### **PUBLIC HEARING MEMORANDUM**

SUBJECT: **Petition #335-21** petition for SPECIAL PERMIT/SITE PLAN APPROVAL to combine two lots and replace an existing three-unit multi-family dwelling with three single-family attached dwelling units, to reduce the required lot area, to reduce lot area per unit, to increase allowed lot coverage, to reduce side setbacks, to allow a three-story structure, to allow a driveway within 10' of the side lot line, to allow parking within 20' of the side and rear lot lines, to allow for reduced driveway width and to allow retaining walls of four feet or more in height within a setback at **10-12 Mechanic Street**, Ward 5, Upper Falls, on land known as Section 51 Block 31 Lots 04 and 05, containing approximately 9,964 sq. ft. of land in a district zoned MULTI RESIDENCE 2. Ref: Sec. 7.3.3, 7.4, 3.4.1, 3.2.4, 6.2.3.B.2, 5.1.7.C, 5.1.13, 5.4.2.B of the City of Newton Rev Zoning Ord, 2017.

**10-12 Mechanic Street**

### ZONING REVIEW MEMORANDUM

***Front & Rear elevations***

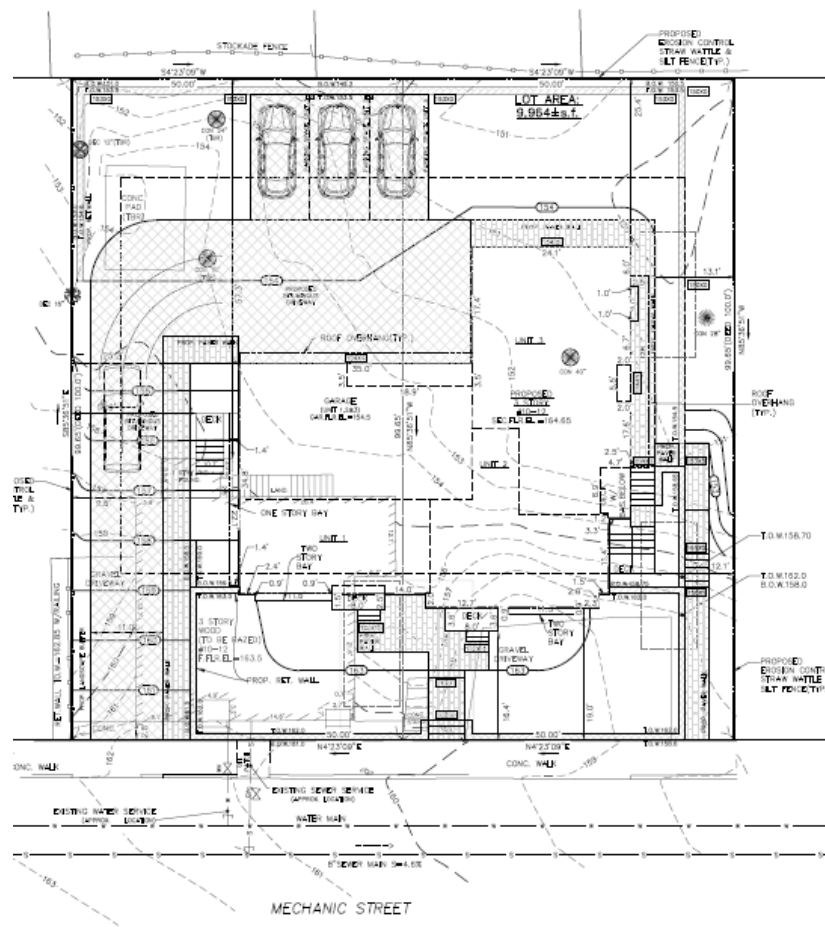
Due to the parcel's grade, the structure presents as having two-stories on the front and three stories at the rear. The proposed height of 34.88 feet is slightly lower than the existing 35.5 feet and the maximum 36 feet allowed. That said, while the proposed three-stories is the same number as the existing structure's, it exceeds the maximum 2.5 stories allowed for single-family attached dwellings.

The three units would measure 2,298, 2,038 and 1,985 square feet. These sizes do not include the common garage located on the first level which would measure 698 square feet. While single family attached dwellings are not subject to floor area ratio (FAR) requirements, the

Planning Department notes that the proposed 7,018 square foot dwelling (including the garage), would have an FAR of 0.70, higher than the calculation for the existing structure on the combined two lots, which would be 0.46, as well as the maximum by-right FAR for a single- or two- family dwelling on the lot of approx. 0.48.
